AMENDMENT TO THE

PIKE RIVER WATERSHED PLAN

KENOSHA AND RACINE COUNTIES

REPORT ON REFINEMENTS MADE TO THE PIKE RIVER WATERSHED PLAN IN CONJUNCTION WITH THE ENVIRONMENTAL IMPACT STATEMENT PROCESS

TYPICAL CROSS-SECTION OF EXISTING AND PROPOSED CHANNEL
ALONG PIKE CREEK, AIRPORT BRANCH, AND TRIBUTARY TO AIRPORT BRANCH

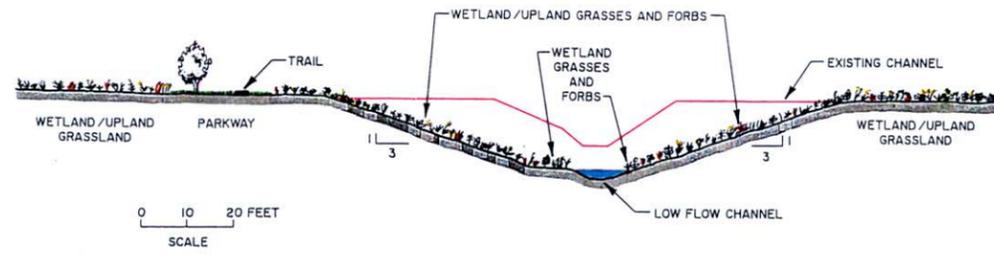
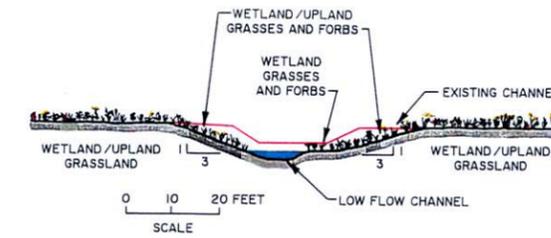
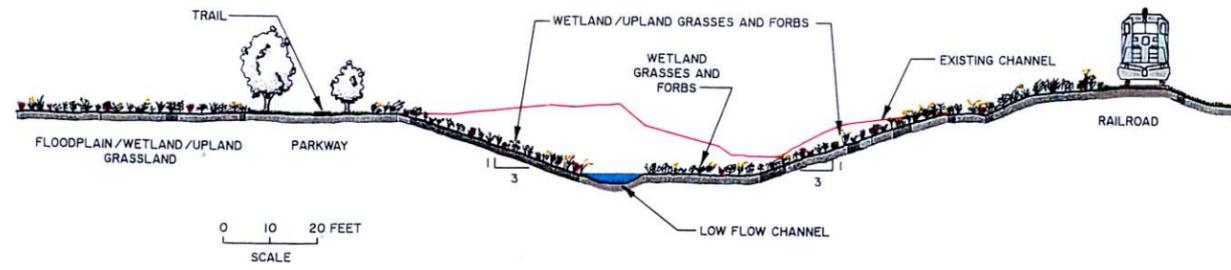
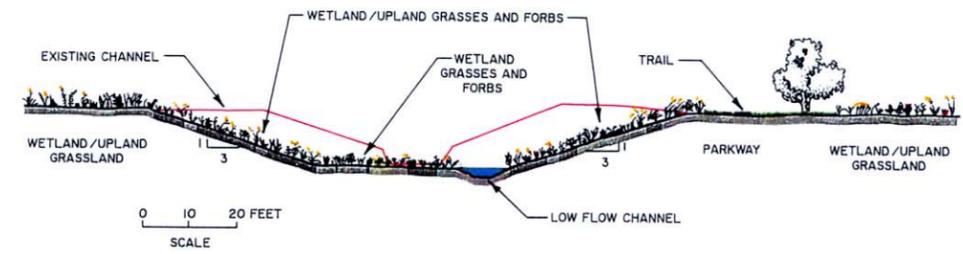
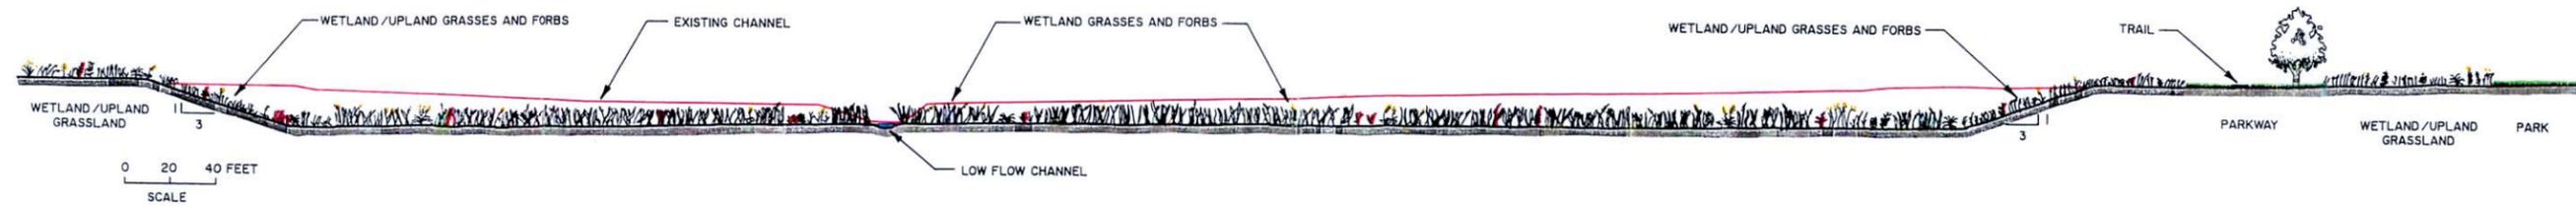
For the reach between STH 50 and CTH K the proposed flood control channel and streambed cross-section would be revised to reflect changes made in March 1992 under SEWRPC Water Resources Simulation Project File No. 235. That project concerned the accommodation of proposed residential development, in the form of the Prairie Lake Estates subdivision, north of STH 50. A wetland restoration along Pike Creek north of STH 50 is to occur as part of that development. Commission review of the project included revised hydrologic and hydraulic analyses which incorporated new topographic data, a refined tributary drainage area, and the addition of floodwater storage related to Prairie Lake as well as existing and planned wetland areas. As a result of the analyses, it was found that the extent of channel modification could be reduced by about 0.3 mile from that originally proposed in the adopted Pike River watershed plan. Channel modifications would now terminate at an existing farm bridge located about 1,200 feet upstream of the CP Rail System (former Chicago, Milwaukee, St. Paul & Pacific Railroad) crossing. Upstream of that farm bridge the existing channel and attendant floodplain would be retained. At CTH K the proposed channel invert would match that recommended under the Pike River watershed plan. The proposed channel would have a bottom width of 22 feet and typical side slopes of one on three.

For the reach between CTH K and CTH L the proposed streambed cross-section would remain as shown in the Pike River watershed plan. Between CTH K and STH 158 the channel would have a bottom width of 22 feet, while between STH 158 and CTH L the channel would have a bottom width of 42 feet. Channel side slopes would be one on three. Final detailed design of the flood control channel may indicate a local need to alter the proposed channel side slope and width to avoid utility conflicts.

For the reach between CTH L and the Town of Somers transfer station drive the proposed streambed cross-section would remain generally as shown in the Pike River watershed plan. For the reach between the Town of Somers transfer station drive and CTH E the proposed streambed would be raised so as to match the existing channel invert at CTH E. The proposed flood control channel would have a bottom width of 42 feet and side slopes of one on three. Final detailed design of the flood control channel may indicate a local need to alter the proposed channel side slope and width to avoid utility conflicts.

The proposed flood control channel and streambed cross-section along the remainder of the Airport Branch and its tributary would remain as shown in the Pike River watershed plan. The channel would have a bottom width ranging from 15 to 25 feet and side slopes of one on three. Final detailed design
